Access Compliance Report

Public Rights-of-Way

Intersection ID: 13648	Main Street: SOUTHWOOD_AV	Cross Street: W_KINGSTON_AV	Location:	N
ADA ID: F2E309BB3474	Ramp Type: BlendTrans2	Initial Pass/Fail: Fail	Overall Compliance: No	Severity Score: 1.25

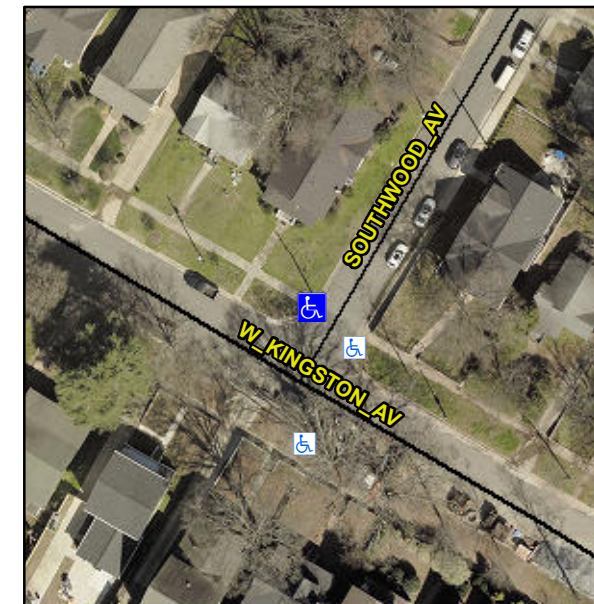
Not Found, R304.5.3

Remove & Replace Curb Ramp With Two New Directional Ramps or Equivalent.
